# Access Compliance Report

## Public Rights-of-Way

Intersection ID: 9711	Main Street: N_DAVIDSON_ST	Cross Street: PATTERSON_ST	Location: SE
ADA ID: AAFA1E7F814C	Ramp Type: Perp	Initial Pass/Fail: Fail	Overall Compliance: No
Severity Score: 8.75			
Codes/Mitigation Info/Possible Solution		Field Measurements/Component Compliance

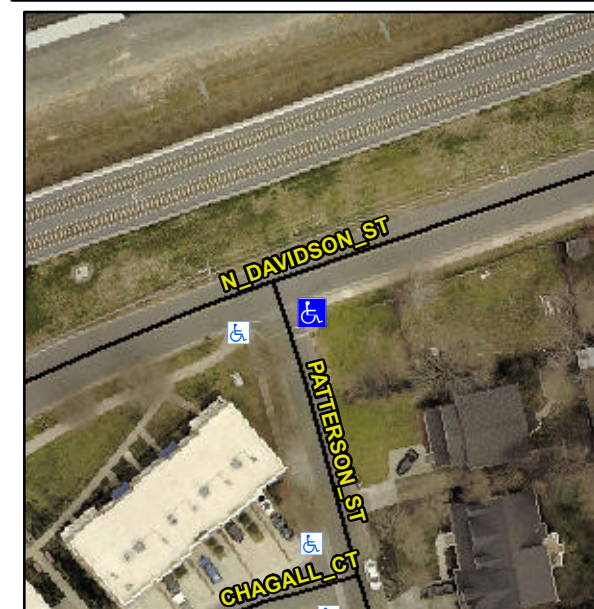
**Not Found, R304.5.1**

Compliance	Description	Data	Compliance	Description	Data
N/A	Ramp Length (in)	50.0	Yes	Ramp Slope (%)	8.0
No	Ramp Width (in)	43.0	Yes	Ramp XSlope (%)	0.2
N/A	Flare Type LT	N/A	N/A	Flare Type RT	N/A
N/A	Flare Slope LT (%)	N/A	N/A	Flare Slope RT (%)	N/A
N/A	Flare Traversable LT?	N/A	N/A	Flare Traversable RT?	N/A
N/A	Landing Length (in)	N/A	N/A	DWS Provided?	N/A
N/A	Landing Width (in)	N/A	N/A	DWS Contrast?	N/A
N/A	Landing Slope (%)	N/A	N/A	DWS Length (in)	N/A
N/A	Landing X Slope (%)	N/A	N/A	DWS Full Width?	N/A
N/A	Landing Curb? (Y/N)	N/A	N/A	DWS Offset (in)	N/A
N/A	Shared Landing?	N/A			
N/A	Gutter Ponding?	N/A	N/A	Gutter Slope (%)	N/A
N/A	Gutter Lip Ht (in)	N/A	N/A	Gutter X Slope (%)	N/A
N/A	Painted X Walk1?	No	N/A	Painted X Walk2?	N/A
	X Walk 1 Direction	To W		X Walk 2 Direction	N/A
N/A	X Walk 1 Width (in)	N/A	N/A	X Walk 2 Width (in)	N/A
	X Walk 1 Slope (%)	1.6		X Walk 2 Slope (%)	N/A
	X Walk 1 X Slope (%)	0.9		X Walk 2 X Slope (%)	N/A

**Remove & Replace Entire Ramp.**
